REMARKS/ARGUMENTS

In response to the Examiner's first Office Action of November 29, 2005 the Applicant respectfully submits the accompanying Amendment to the specification, drawings and claims, and the below Remarks.

FIG. 43

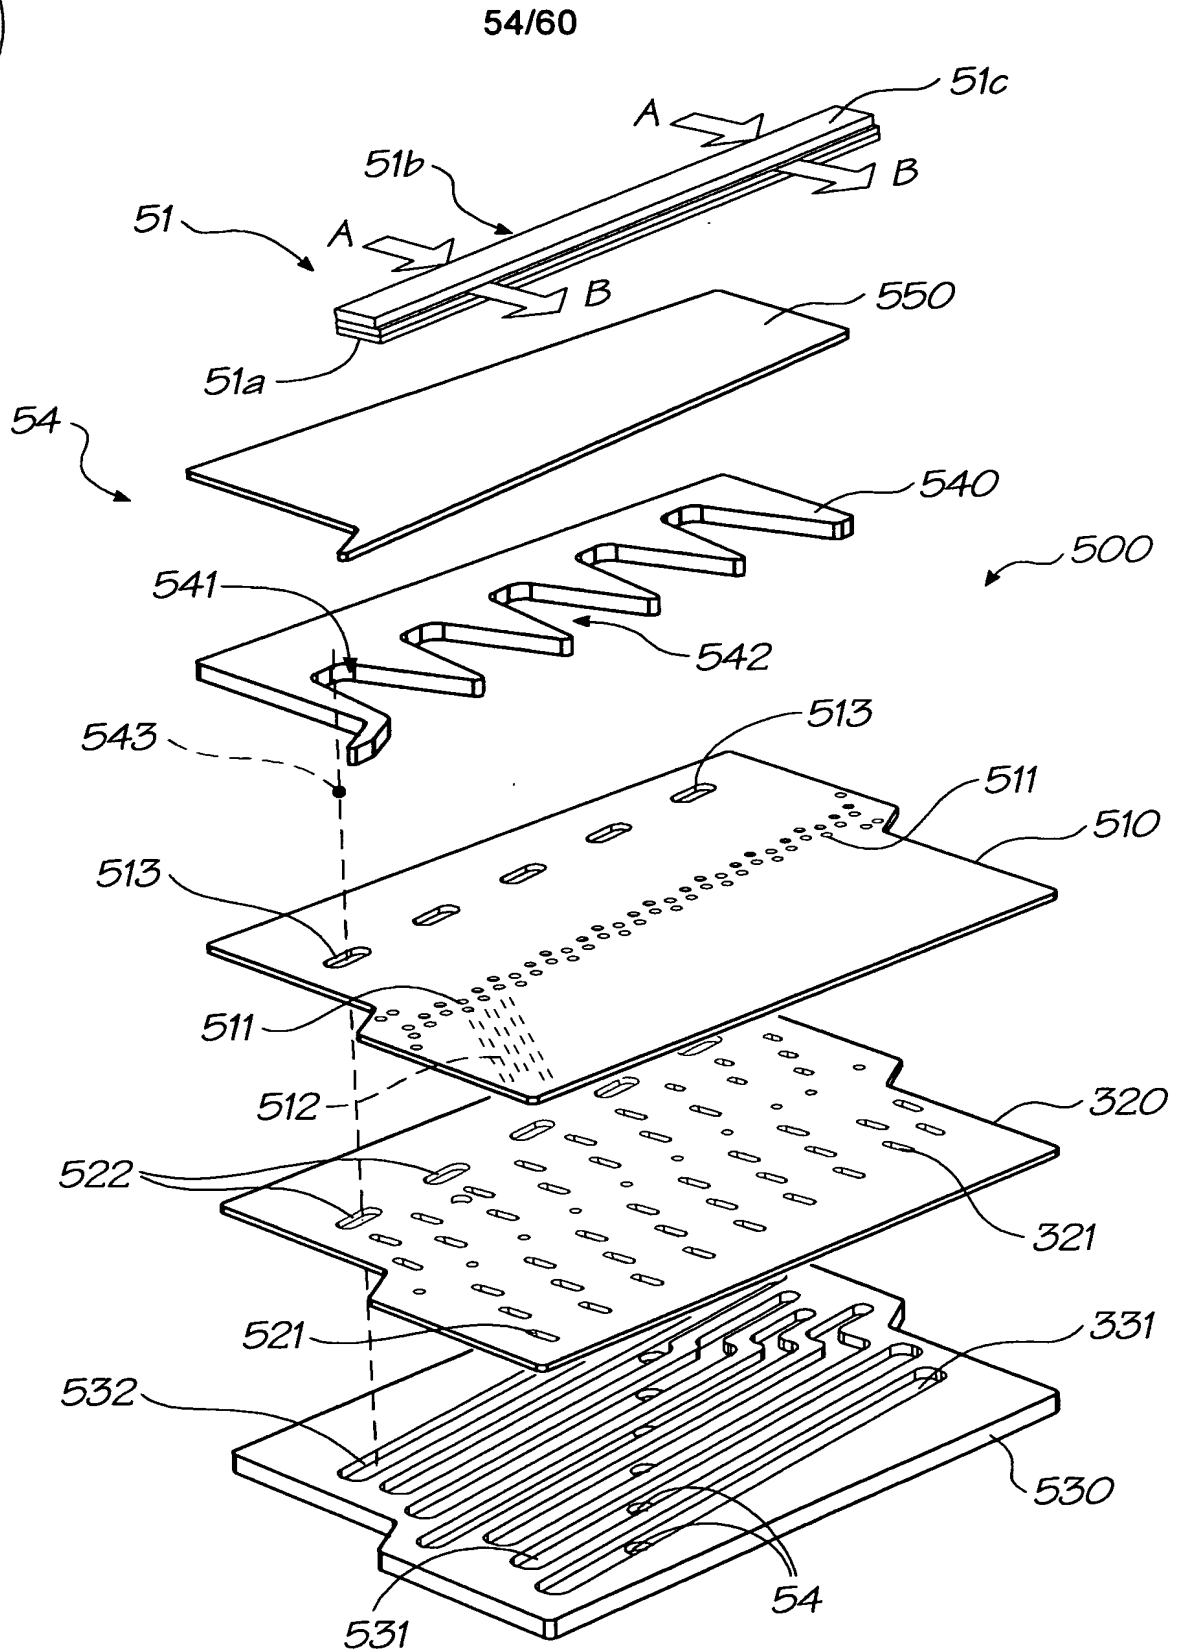
Regarding reference sign "500"

Fig. 43 is amended to include the reference sign "500", as is described at page 8, lines 25-33 of the present specification;

It is respectfully submitted that the above-described amendment to Fig. 43 to insert the reference sign "500", provides the correction required by the Examiner.

A corrected Fig. 43 is enclosed.
